Agenda Item #2 Application 2025-28-CA

273 Park Terrace

Window replacement

Leinkauf

6. View of rear elevation, looking S

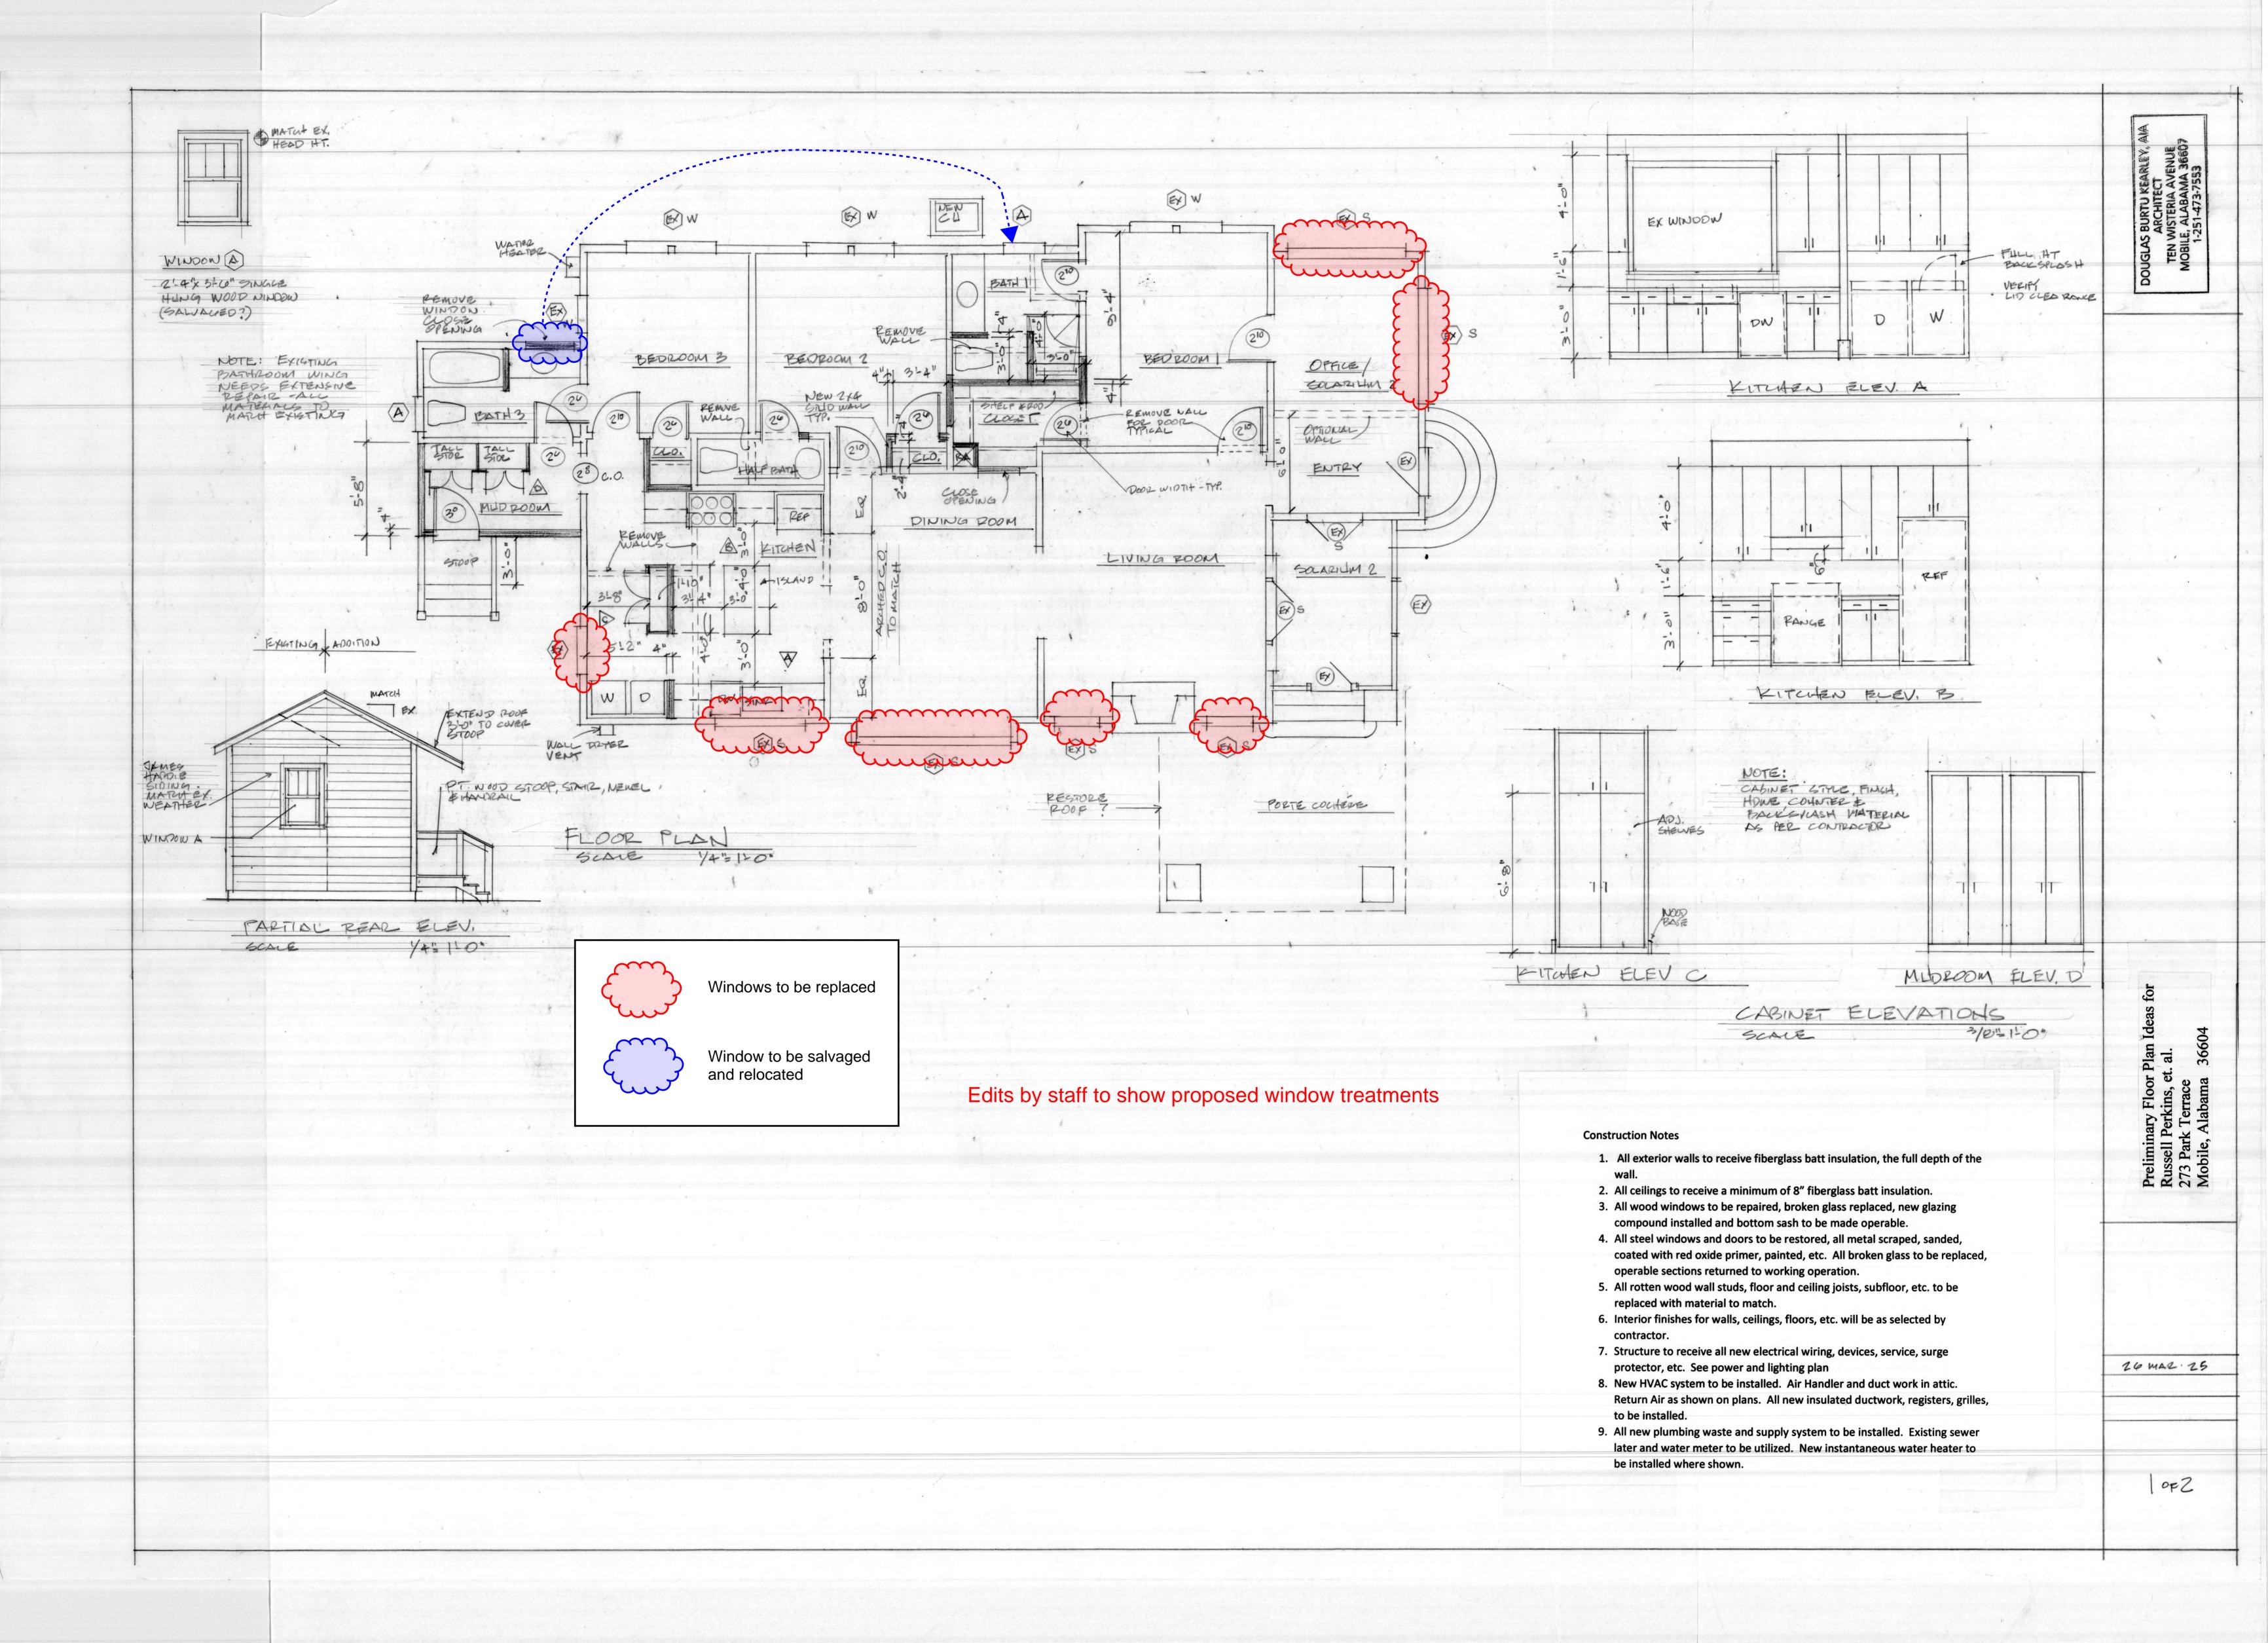
The proposed removal of a historic window on the rear does little to impact the existing rhythm along the home's exterior elevations; and the reuse of this removed window at a current opening along the south elevation is considered best practice. All other windows and doors would be repaired in-kind. The remaining alterations proposed for the structure are eligible for administrative review.

Back Window— will be replaced with the below custom window to provide exact look.

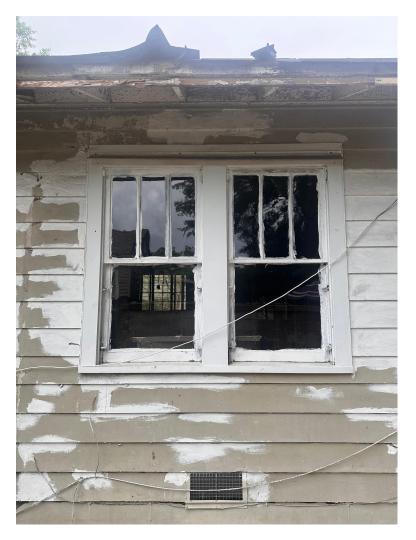
LineItem #	Description	Net Price	Extended
LineItem # 1-1 Qty: 1 Room Location: None Assigned Note:	Rough Opening: 36 X 90, Frame: 35.5 X 89.5 Product Unit 1:1500 Rectangle Unit 2:1500 Casement Unit 3:1500 Rectangle Dimensions Unit 1: Traditional (1/2" under Call Size), Custom, Frame Size 35.5 X 27 Unit 2: Traditional (1/2" under Call Size), Custom, Frame Size 35.5 X 48.5 Unit 3: Traditional (1/2" under Call Size), Custom, Frame Size 35.5 X 13 Color Exterior = Black, Interior = White Unit Type Unit 1, 3: Matching Window Type = Casement, Nailing Fin Unit 2: Left, Nailing Fin Unit 2: Left, Nailing Fin Unit 2: Left, Nailing Fin Unit 2: Casement, Unit 1, 3: FW-R60 (DP +60/-60), Florida Approval # 15325.6, No Thermal Requirement, U-Factor = 0.33, SHGC = 0.2, VLT = 0.38, CPD = PWG-M-53-03086-00001, STC Rating = 25 Unit 2: C-LC50 (DP +50/-50), Florida Approval # 15317.8, No Thermal Requirement, U-Factor = 0.32, SHGC = 0.18, VLT = 0.33, CPD = PWG-M-54-02894-00001, STC Rating = 28 Glass LE-SC (Low-E SC), Warm Edge (WE), Metal, Double Glazed, 3/4", Tempered Grilles Unit 1: 3/4" Flat GBG, Colonial, Exterior = Black, Interior = White, 2W2H Unit 2: 3/4" Flat GBG, Colonial, Exterior = Black, Interior = White, 2W2H Unit 2: 3/4" Flat GBG, Colonial, Exterior = Black, Interior = White, 2W2H Unit 2: 3/4" Flat GBG, Colonial, Exterior = Black, Interior = White, 2W1H Hardware White, Standard Handle Screen No Screen Wrapping - Frame Options Nail Fin Setback 1 1/4" Wrapping - Overall Performance DP+50/-50 Mulls Mulls 1: Horizontal Factory 0.5" thick	Net Price \$2,755.93	\$2,755.93
